ARCHITECTURAL DESIGN NARRATIVE BACKGROUND

8500 N PFEIL STREET, MILWAUKEE, WI 53224

CPC STAFF REVIEW COMMENTS:

EAST ELEVATION

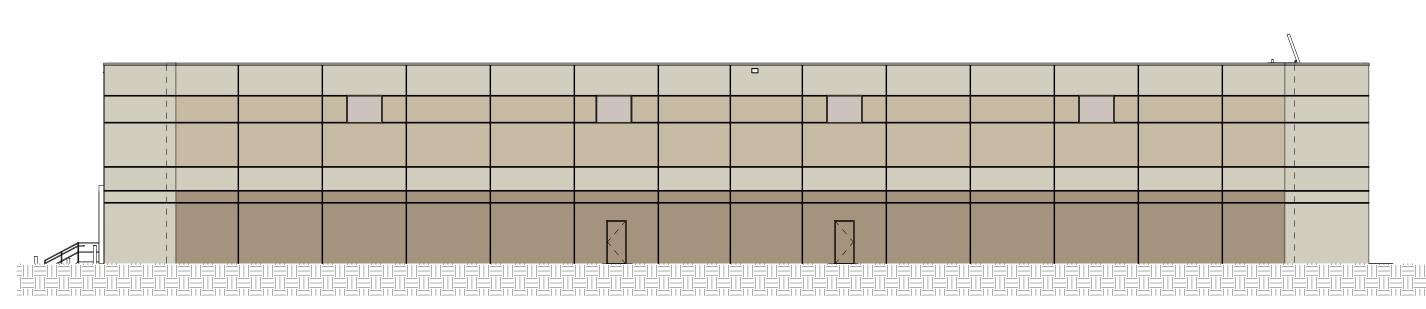
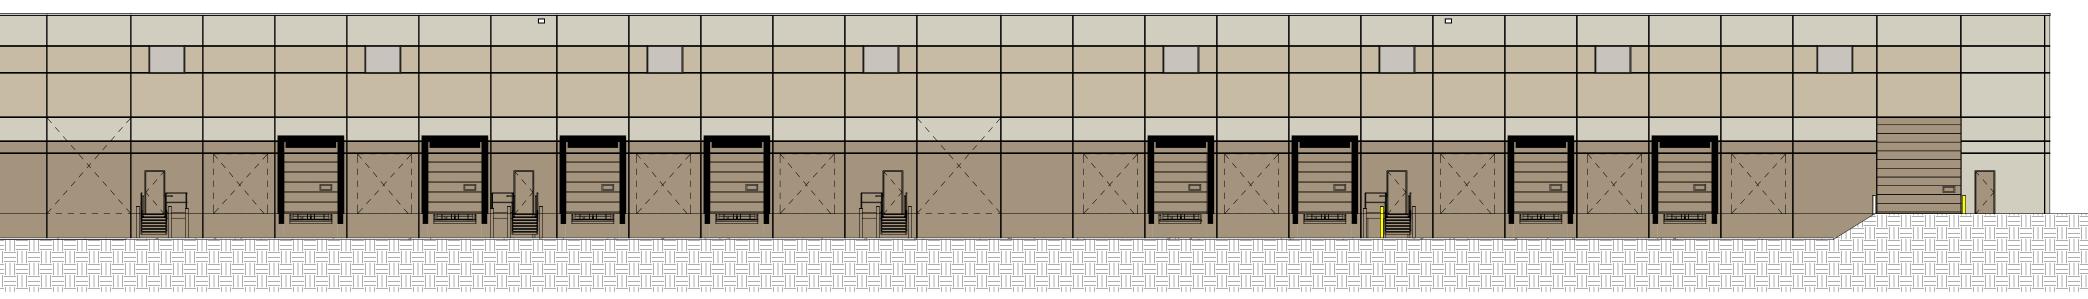
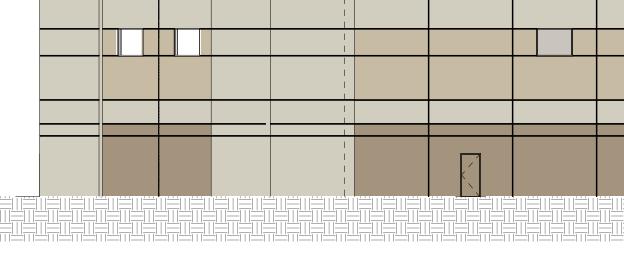
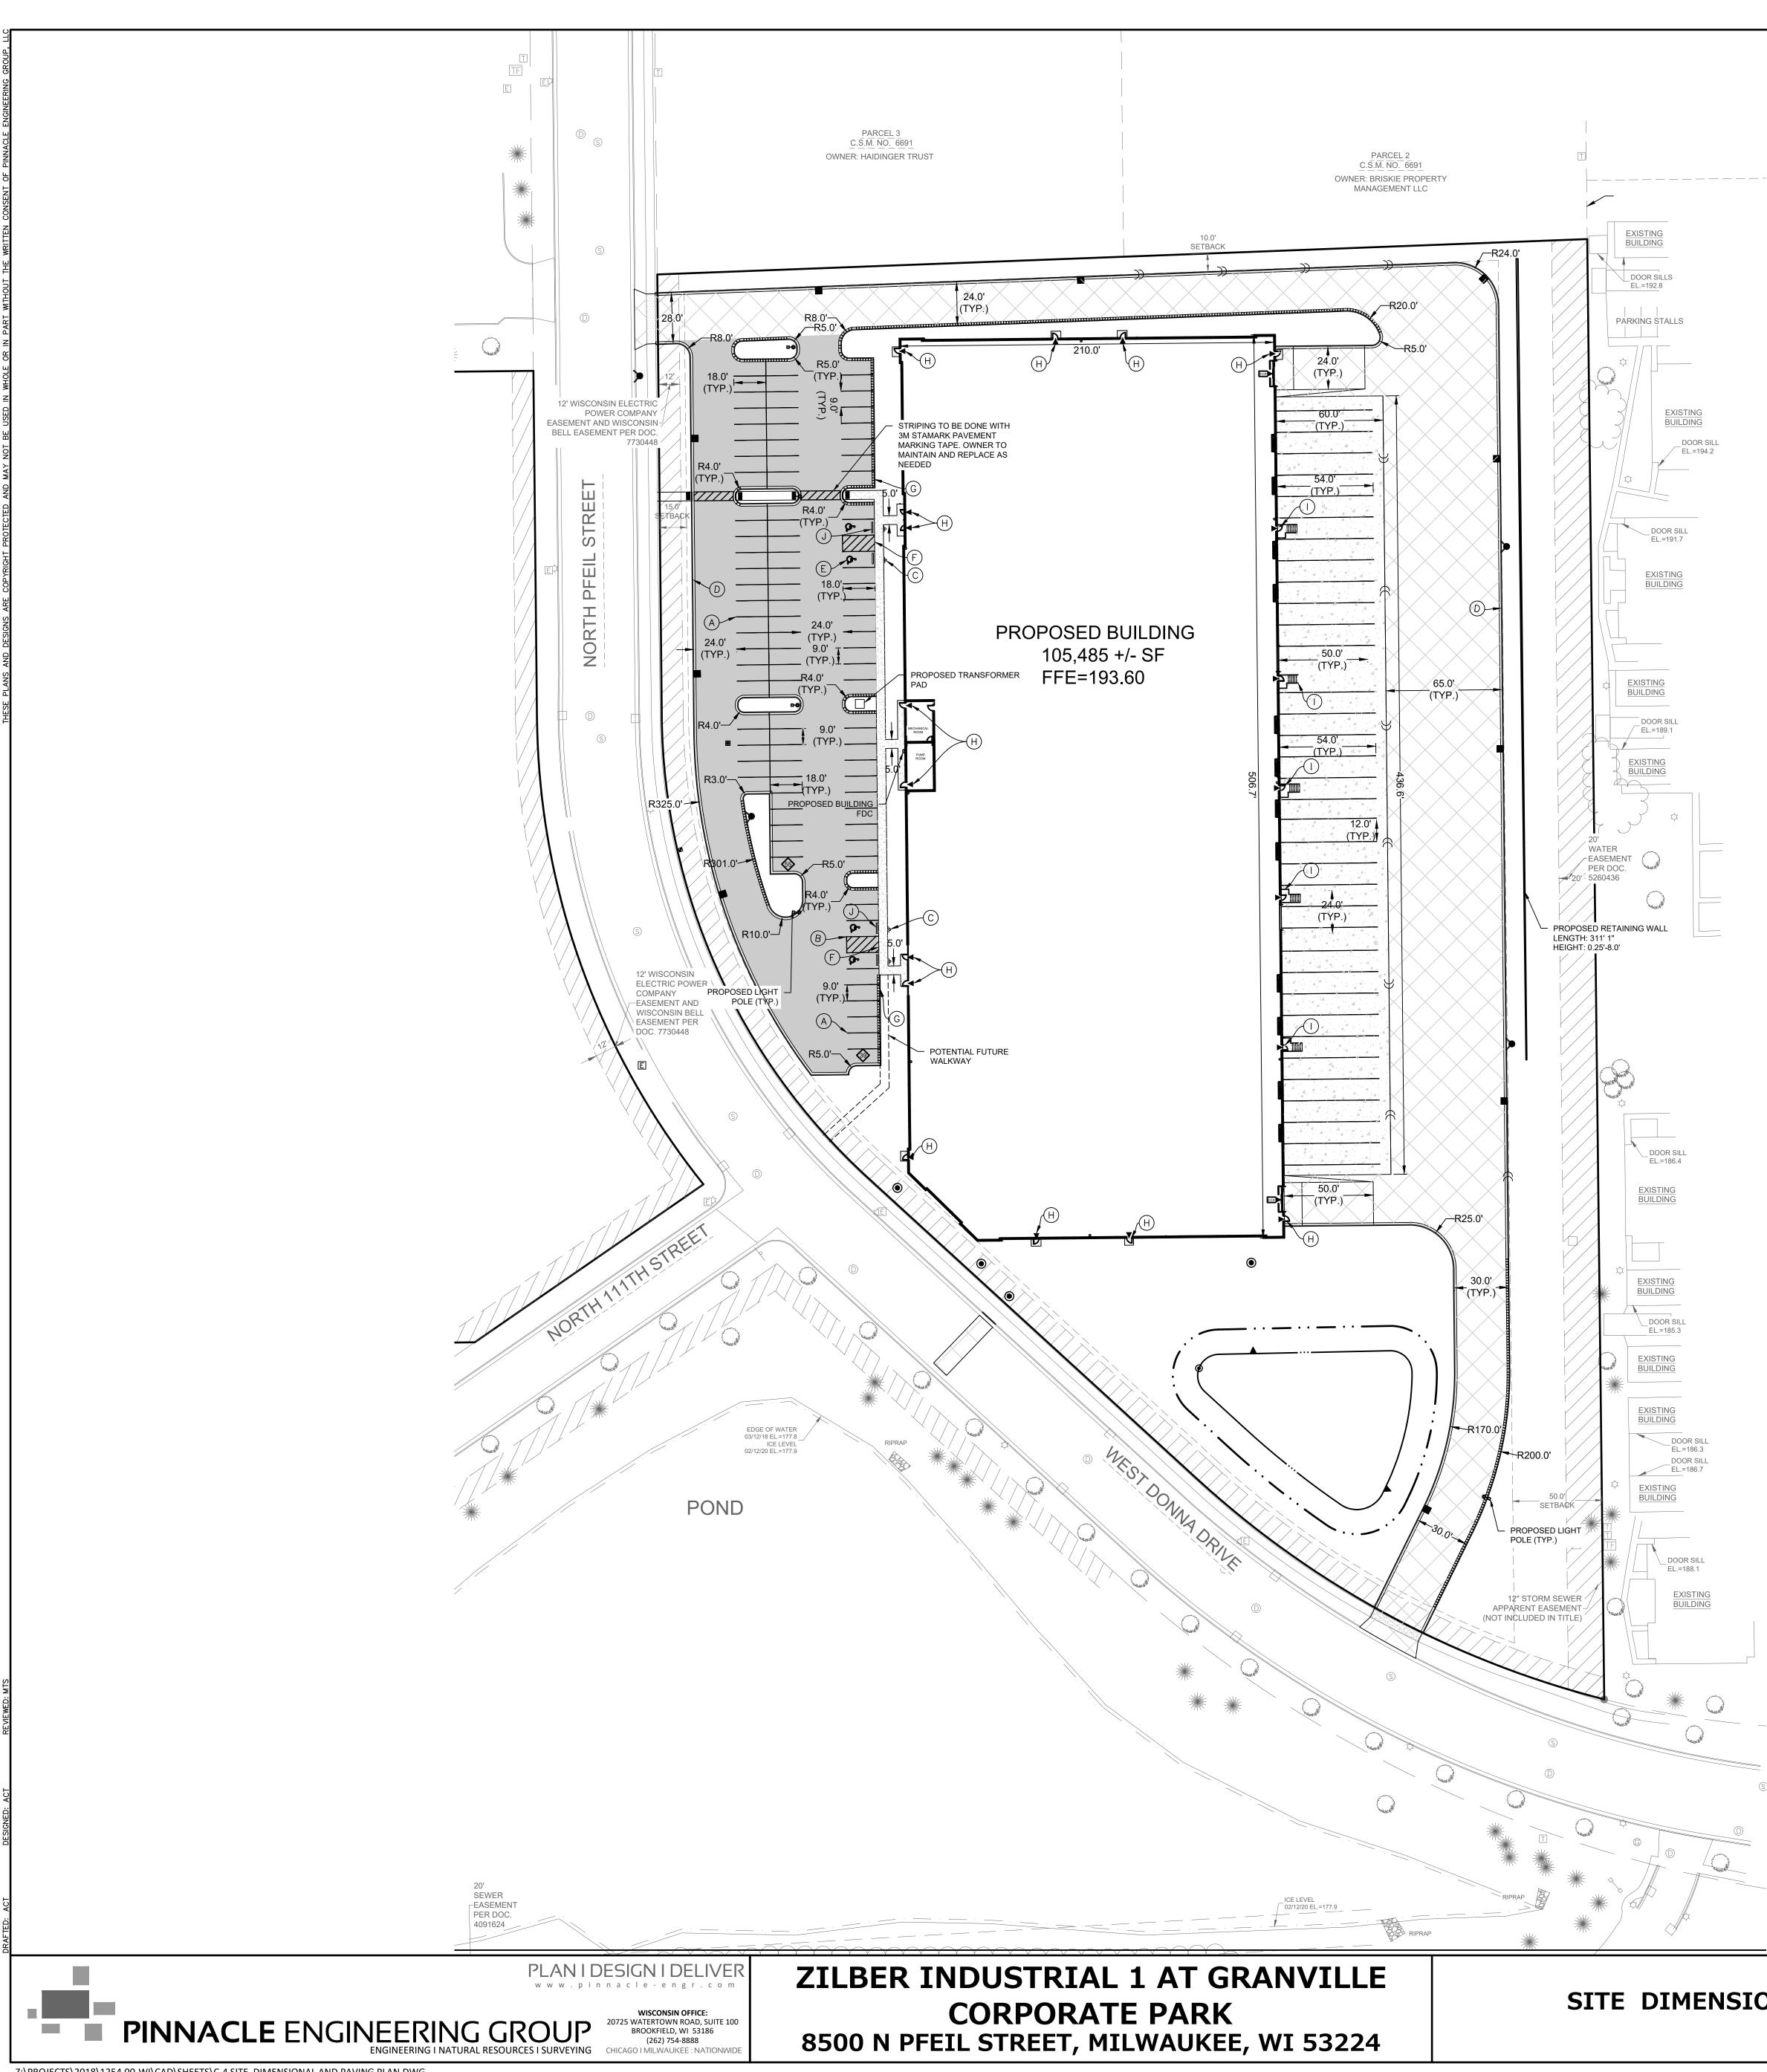
- 2. Building facades:
 - a. The DIZ standards call for long, uninterrupted facades to be avoided by adding windows and openings, recessed portals, varying color and texture, building articulation and architectural details. We understand that this is a speculative building, and as such, it is currently unknown which windows will be able to be added on the first floor. Given the scale of this building, and particularly the Pfeil-facing elevation, we suggest that additional vertical emphasis is added. While the concrete panel exterior does have both vertical and horizontal scoring, the vertical proportions could benefit from further emphasis. A break in the parapet along the long horizontal parapet (such as dropping it

down by a few feet) with corresponding panel scoring could help to achieve this. These breaks should occur near the corner differentiation as well as mid points along the long parapet runs.

- Other methods that might work include adding upper level vertically shaped windows into the building, or additional off-sets to the exterior wall. See 2A for design modifications

The attached renderings are in response to the Plan commission's concerns of a "long uninterrupted horizontal wall", given the fact that we have a introduced a plan change by offsetting the precast panels on the corners, bumped up the entries, and created a gap to highlight the entries, our solution is playing with the paint scheme, painting the center two panels with the lighter color similar to the corners, introducing a vertical element that breaks up the wall further. The roof and structure were designed to allow for the minimum precast wall height while maintaining the desired clear height for a speculative tenant.

Z:\PROJECTS\2018\1254.00-WI\CAD\SHEETS\C-4 SITE DIMENSIONAL AND PAVING PLAN.DWG

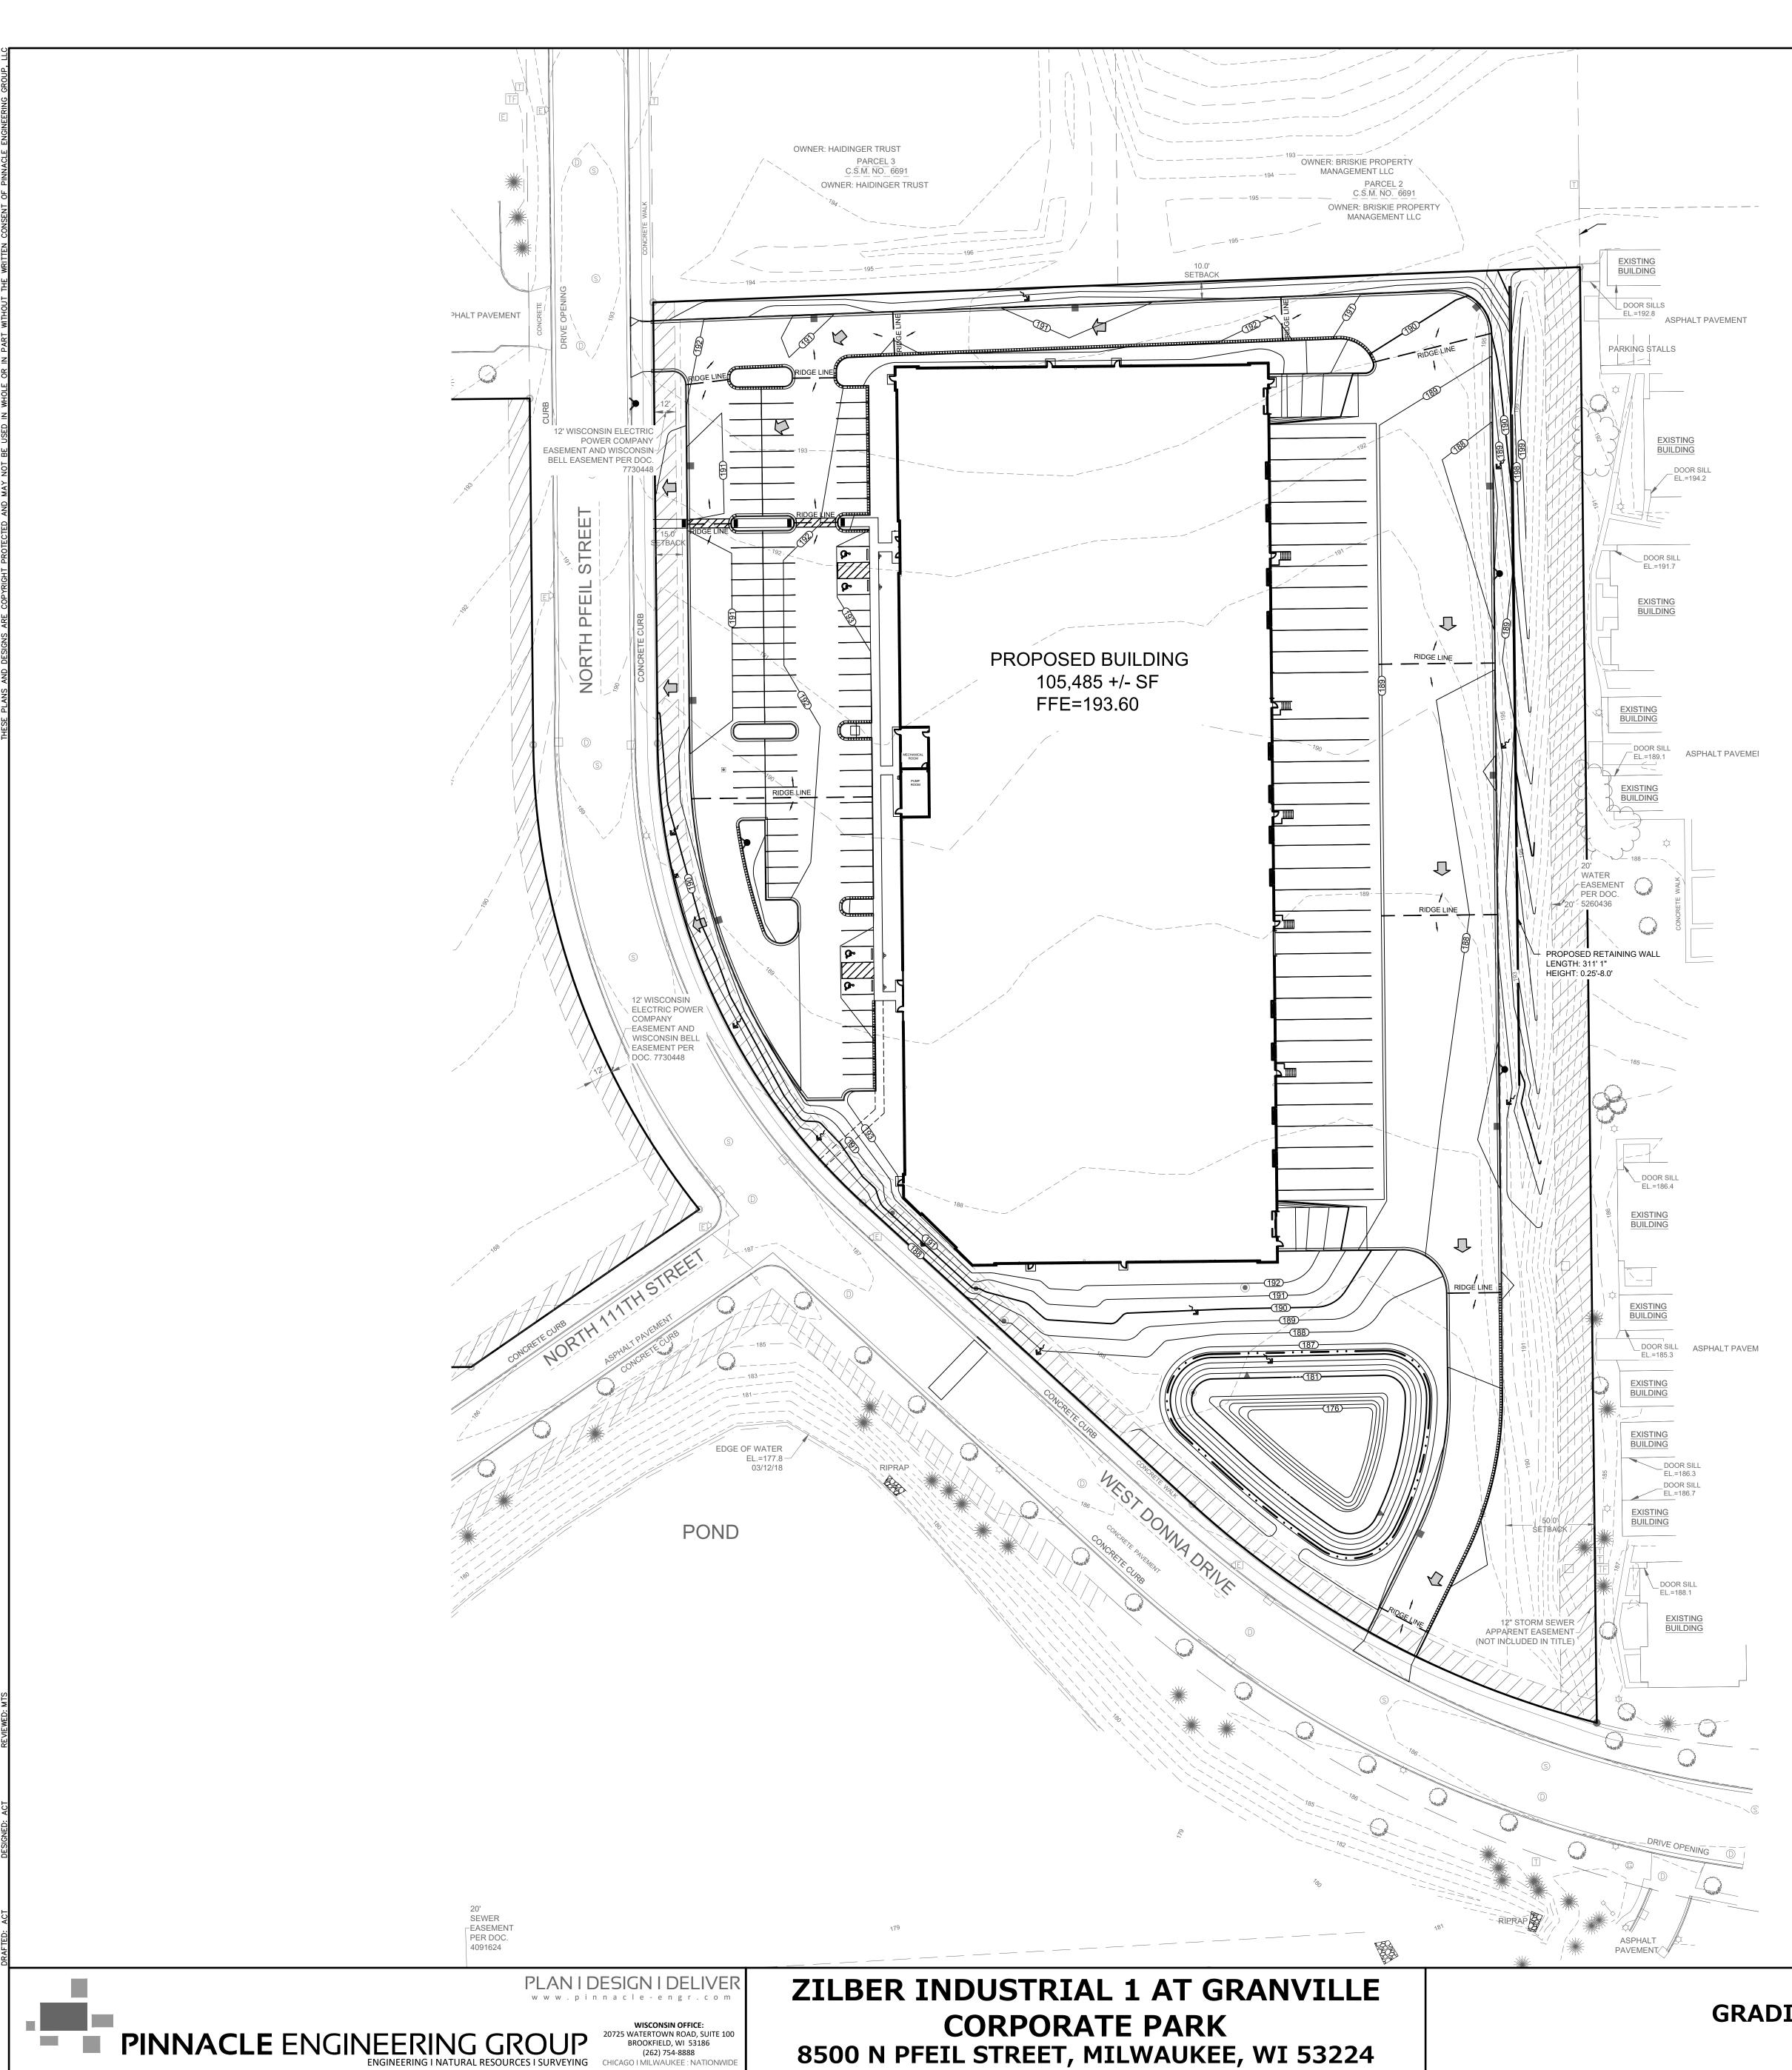
- 1. Site/landscape plan:
 - a. Please add a pedestrian sidewalk linking the entrances to the public sidewalk, as required by both the DIZ and the IL1 zoning. The sidewalk should be a minimum of 5' in width, but preferably wider. The crossing at the parking lots should be concrete and level with the asphalt surface.

A 6' sidewalk was added connection both main entries to the public walk way. Additionally a future sidewalk was added to the south to create a shorter path connection to the south. As for the crossings: asphalt and concrete settle at very different rates and after a few Wisconsin winters, the edges of the concrete will be busted up and the asphalt will have settled. It creates a trip hazard and I would like to do some other method. In past projects in the city we have proposed a pavement marking tape that is embedded in the asphalt surface course. They lay it down and the roller compacts it in place. It provides a permanent striped walkway without the wear of traditional paint. Owner agrees to maintain and replace as necessary.
